DOCUMENT NUMBER: 17-00176 RELATED DOCUMENTS:

VCO1 Unlock in 9323 & 9360 series transceivers

Figure 1. Location of C103

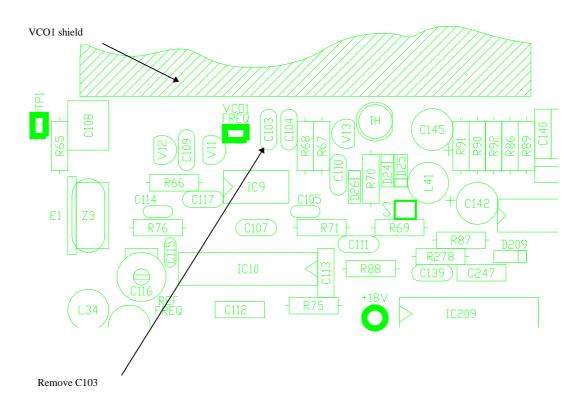
The unlock error is caused by the RF energy from the VHF/UHF transmitter disturbing the normal operation of the VCO1 control circuit.

- Remove the transceiver from the installation.
- ☐ Remove the two screws securing the top cover.
- □ Locate the Receiver Exciter Printed Circuit Board (PCB), 08-04962.
- ☐ Disconnect all the connectors from the PCB.
- ☐ Remove the seven screws securing the PCB.
- ☐ Withdraw the PCB from the chassis.
- □ Locate and remove C103 from the PCB. Refer to Figure 1.

\Box Trim and solder one lead of the 1 kΩ resistor to IC9 pin 4. Refer to Figure 2.

- ☐ Fit one lead of the capacitor into the bottom hole for C103. Trim and solder.
- □ Solder the remaining leads of the capacitor and the resistor together.

- ☐ With the transistor flat side up, solder the centre lead to the leads of the capacitor and resistor. Trim any excess lead.
- ☐ Trim and solder the Collector of the transistor to IC9 pin 8.
- Fit the Base of the transistor into the upper most hole for C103. Trim and solder.
- ☐ Ensure there is no possibility of a short circuit occurring particularly to the test point labelled VCO1 FREQ.
- ☐ Secure the transistor with some silicon sealant if necessary.
- ☐ Secure the PCB into the chassis with the seven screws.
- ☐ Replace all connectors.
